Planning and Urban Design

To: City Planning Commission
From: Planning and Urban Design Staff
Date: September 13, 2021
Re: **SP2021-034**

Purpose:
Special Use Permit for a liquor store.

Property Location:
8537 State Avenue
Kansas City, Kansas 66112

AS1

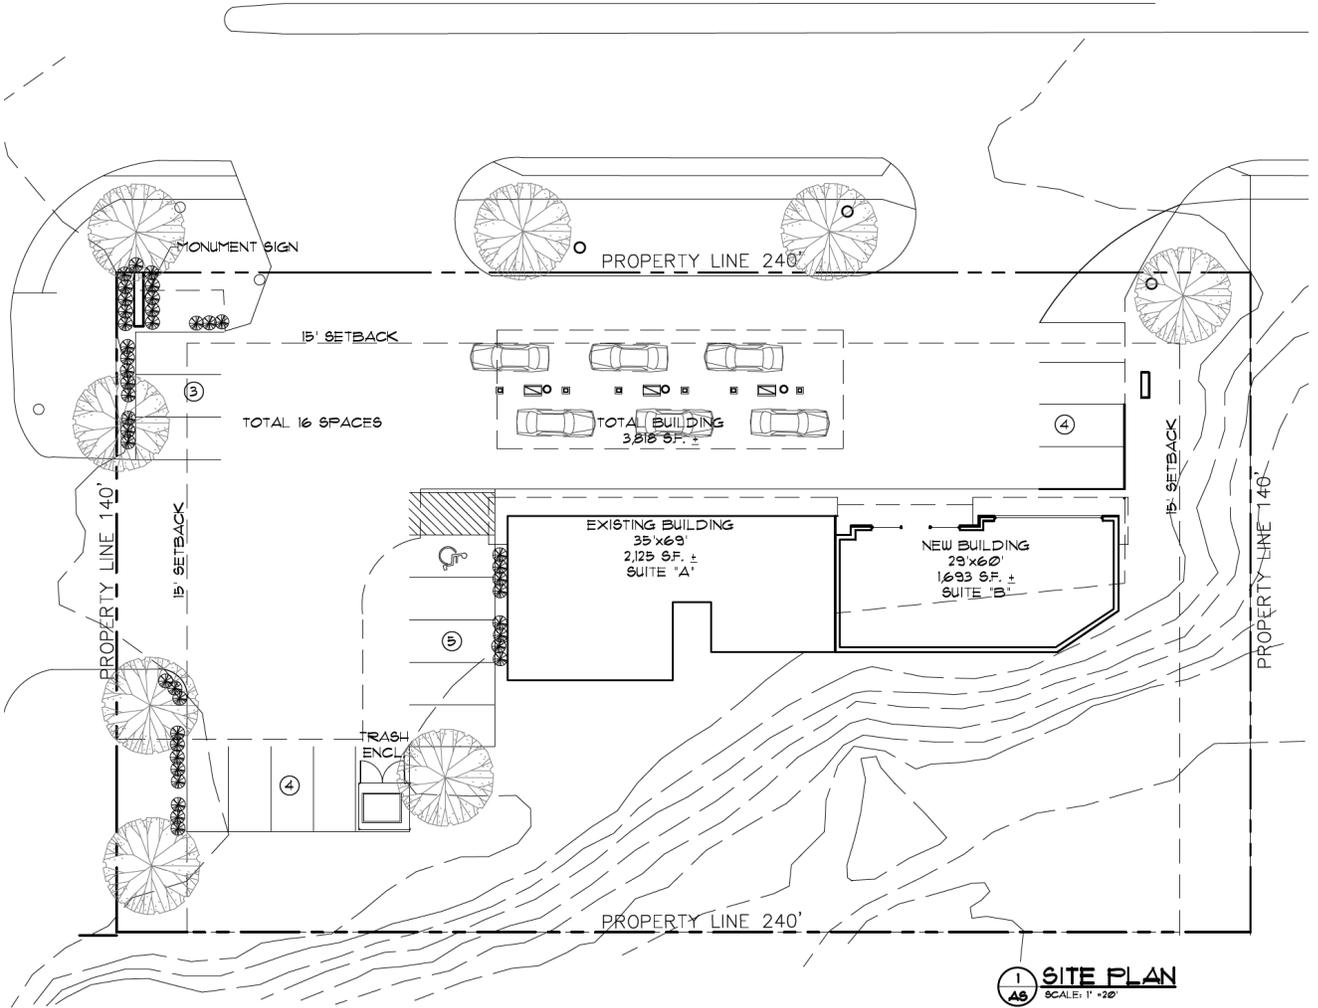
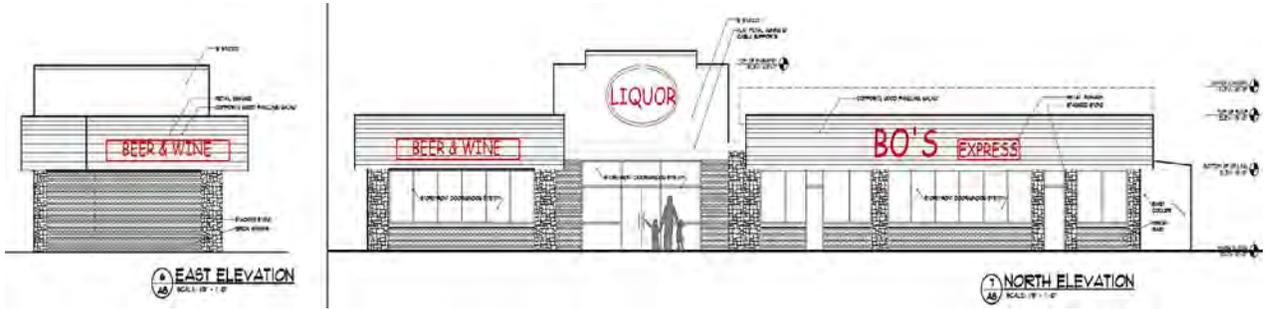
- 3) Landscape is required to screen all parking areas and service entries. Provide a site plan that demonstrates satisfactory landscaping of all parking and service areas.

- a. The requirements of the parking lot will depend on the quantity and location of parking spaces as demonstrated on the parking plan, as well as the use-based parking requirements of Section 27-668. Provide a parking plan for the property, demonstrating all required parking spaces, dimensions, and other required features such as parking lot islands and vegetative buffers.

- a. Per Section 27-575(f)(1), there should be a designated walkway or clear pathway to the main entrance of a building so that pedestrians are not required to walk through parking lots. Provide a revised site plan demonstrating a designated pedestrian walkway from the public sidewalk to the entrance of the store.
- b. Per Section 27-575(f)(2), buildings should be located in such a manner as to minimize conflicts between pedestrians and automobiles.
- c. Per Section 27-575(f)(3), buildings should be oriented primarily to the street.
- d. Per Section 27-575(f)(4), retail shops at street level should have direct access to and from the sidewalk.
- e. Per Section 27-575(f)(5), entrances should be easily identifiable as primary points of access to buildings.

LANDSCAPE PLAN SUBMITTED BY THE APPLICANT

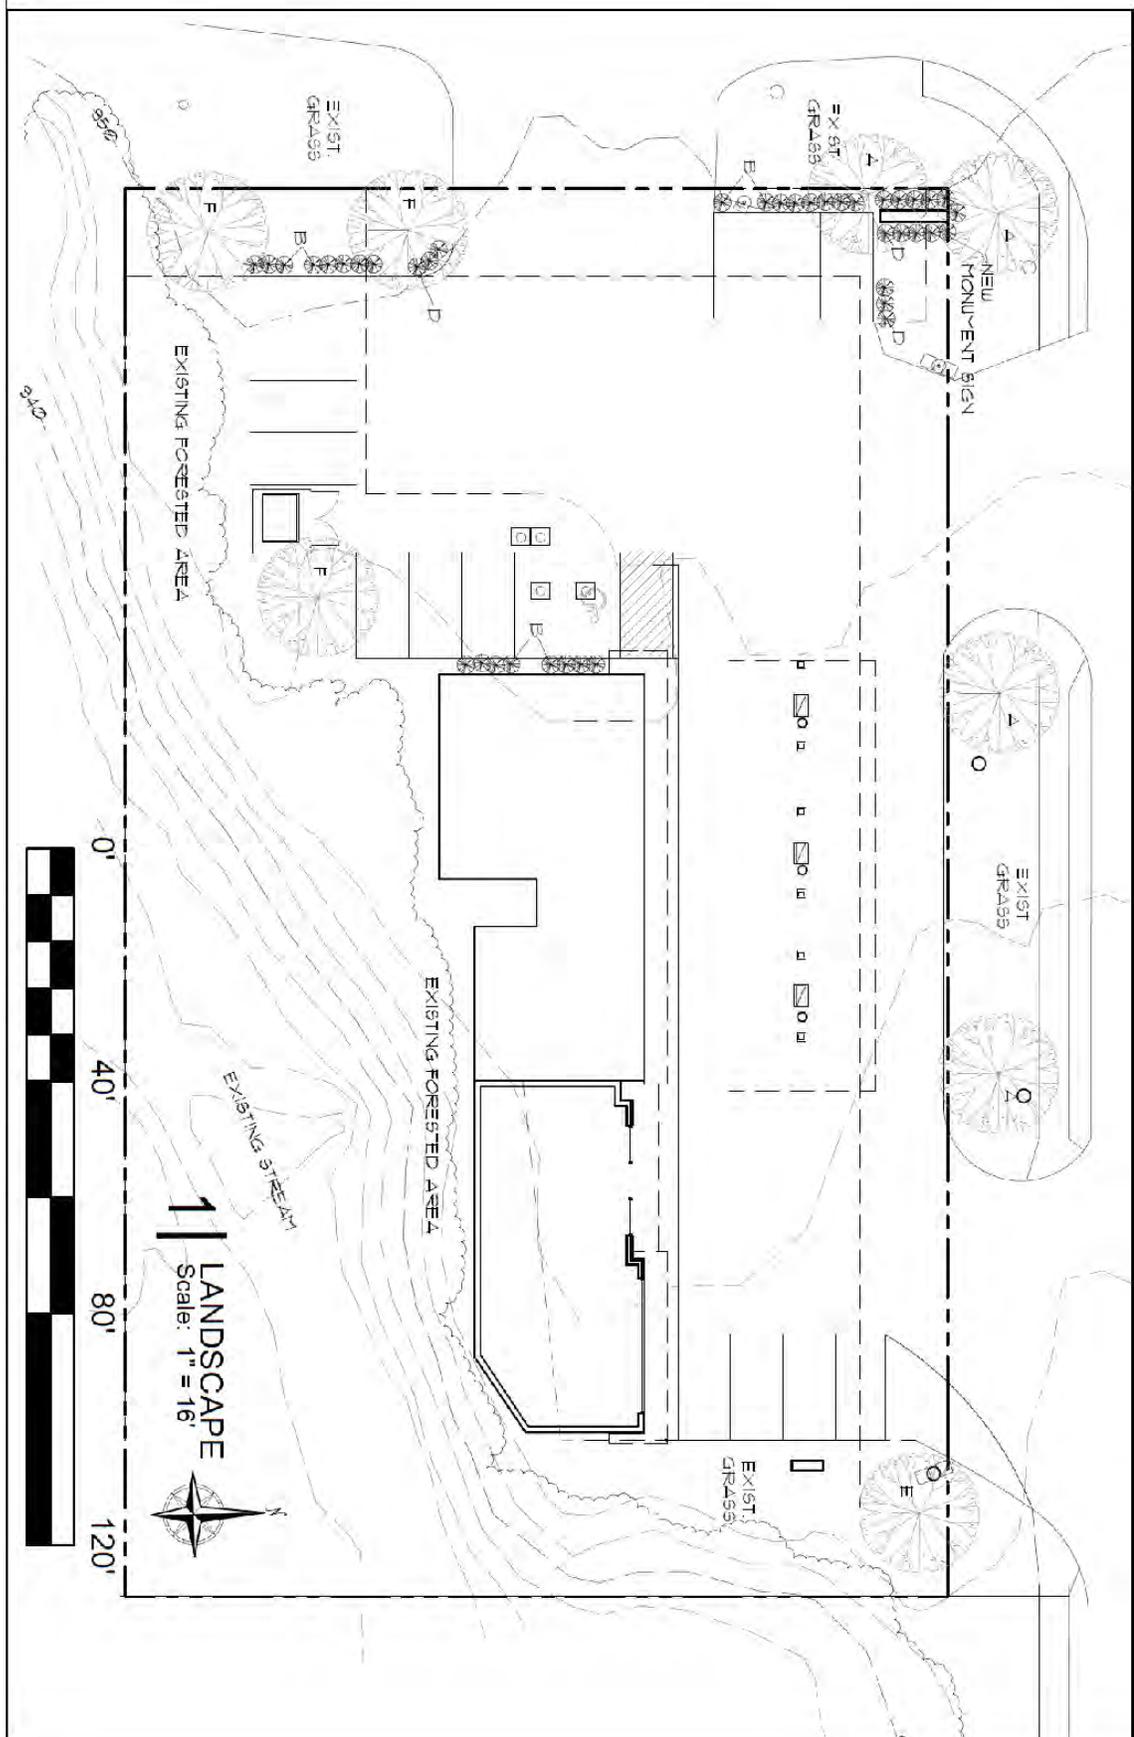
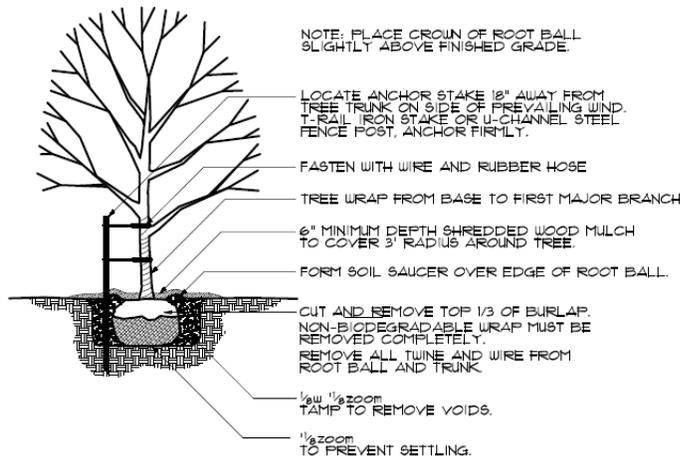
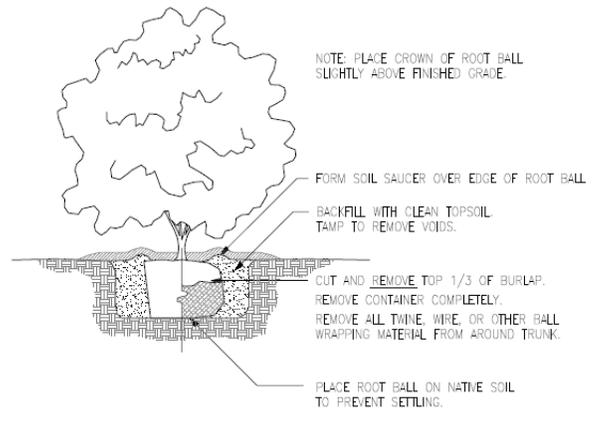
Staff Response: The applicant has failed to provide a landscape plan.

Staff Response: None of the applicant's submitted documents shows any sign of preserving the southern stand of trees. The applicant must submit a landscape plan.

- 1) **The applicant has not met all landscaping requirements. The applicant must submit a revised landscaping plan by September 22, 2021 that addresses the following:**

- g. **Per the Mixed-Use Design Guidelines in the City-Wide Master Plan, trees are required in the public right-of-way along streets, at a minimum of one (1) shade tree every forty (40) feet. Two (2) additional trees need to be demonstrated in a revised landscape plan;**

- h. **Per section 27-577(a)(5), landscaping shall exceed the typical code requirements by at least 75 percent. The subject parcel is 0.77 acre, or approximately 33,541 square feet. $(33,541/7,000)*1.75 = 8.4$; therefore, the applicant must submit a landscape plan that**

- demonstrates at least nine (9) trees on the property, not including any tree required by parking lot standards;
- 2) Per the Commercial Development Guidelines Overlay District, the following regulations must be either met or a deviation from such regulations must be approved by the City Planning Commission:
